### DIVISION OF PUBLIC UTILITIES

### Memorandum

RE: Docket 03-2035-01: *In the Matter of the Acknowledgment of PacifiCorp's Integrated Resource Plan 2003*

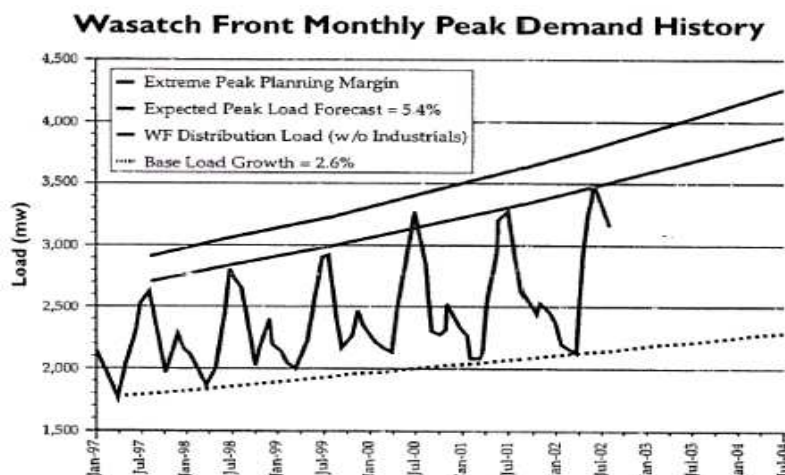
The Division is particularly concerned that the Company forecasts that peak demand in the East will increase at double the rate of average load growth. In addition, the IRP has identified that PacifiCorp East has transmission limitations creating difficulties getting power into particularly high growth areas in Utah. In Utah Power’s “Voices” insert in March customer bills included the following graph

The graph represents the historical load as well as what the Company estimates for loads along the Wasatch Front. The Company expects base load growth to be 2.6% but its expected peak load forecast is 5.4%. We have estimated what impact it would have on capacity needs if peak grew at about the same level as base load. (We do not have the numbers behind this graph therefore we must estimate.) It appears that this graph is demonstrating that, at peak in 2002, the Wasatch Front demand was about 3500 MW. If peak demand grows at the anticipated 5.4%, demand will be about 3888 MW by 2004 compared to 3684 MW if peak grew at 2.6%, the same as base load. This is a difference of about 200 MW. The amount of capacity needed for what is termed "Extreme Peak Planning Margin" adds to the problem. The extreme peakiness of the Wasatch Front load adds to the problem. According to the graph, in 2002 there was a difference of about 1400 MW between base load and peak demand further demonstrating how critical it is to manage peak growth in Utah.

In short, the Division does not accept that the rate of peak load growth is a given. The Division believes that significant reductions in peak growth can be secured through effective implementation of demand side and other measures that could significantly change the type of resources needed if peak growth were effectively managed to be more aligned with average growth.

Therefore, the Division recommends the development of a local resource planning process that builds on this 2003 Integrated Resource Plan to begin in the second quarter of 2003. Such a process would include evaluation of distribution investment, demand side alternatives, rate design, combined heat and power, and distributed generation, along with supply and transmission investments as modeled in this current IRP. Based on the outcome of the local planning process, PacifiCorp will need to refine its estimates of peak load growth going forward as measures are implemented leading to manage peak demand, especially within the Utah jurisdiction
